Uncertainties Associated with the Proposed Shielding Calculation Method for the SAFKEG-HS 3977A Package

Title	Uncertainties Associated with the Proposed Shielding Calculation Method for the SAFKEG-HS 3977A Package	Number	CTR 2013/09
		Issue	A
		File Reference	CTR 2013-09 Issue A Uncertainties Associated with the Proposed Shielding Calculation.docx
Compiled		Checked	
	S Marshall		RA Vaughan
Approved		Date	18 th April 2013
	RA Vaughan		
Croft Associates Ltd, F4 Culham Science Centre, Abingdon, Oxfordshire. OX14 3DB, Tel +44 (0)1865 407740

This report has been produced in response to the Nuclear Regulatory Commission, Request for Additional information sent on March 21, 2013. It specifically responds to the comments raised in items 5.10 and 5.11. These comments require Croft to respond concerning all the uncertainties found with the model used to calculate the dose rate on the surface of the package. These uncertainties include, the method of converting the photon flux to a dose rate, the changes caused by using the minimum tolerances for all the materials and the effect of the damage on the package from the NCT and HAC tests.

Figure 6 - ANS dose rate vs ICRP dose rate

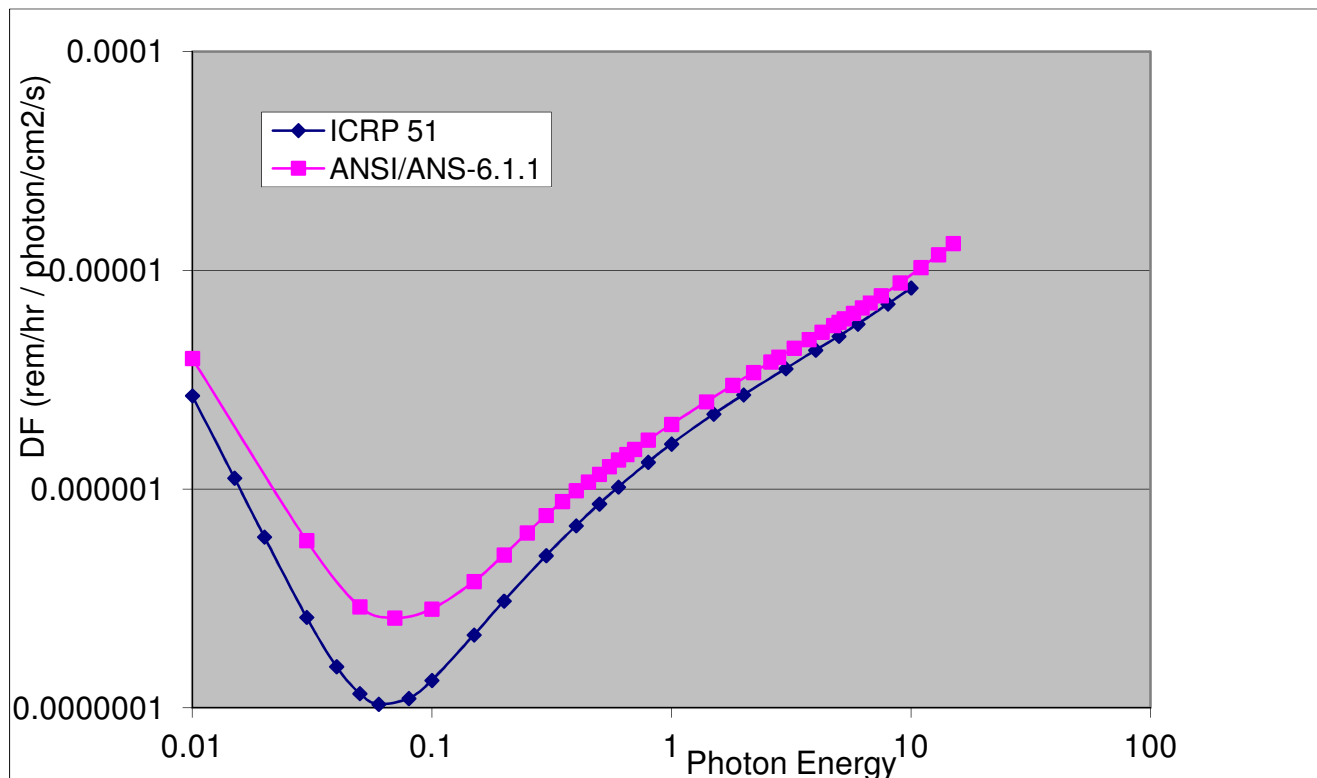
The original shielding calculations given in CTR 2011/01 issue A used ICRP 51 (1987) Table 2 to convert photon energy to dose rate. This however provides an organ dose rate rather than a measured dose rate. The NRC also advocate the use of ANSI/ANS-6.1.1-1977 as this provides higher surface dose rates than those in ICRP 51 as shown by Figure 6.

For the nuclides discussed in section 2 the photon flux was converted into dose rate using the following equation given in ANSI/ANS-6.1.1

As shown in table 1 the maximum difference between the figure provided in CTR 2011/01 and those calculated using ANSI/ANS is 37%.
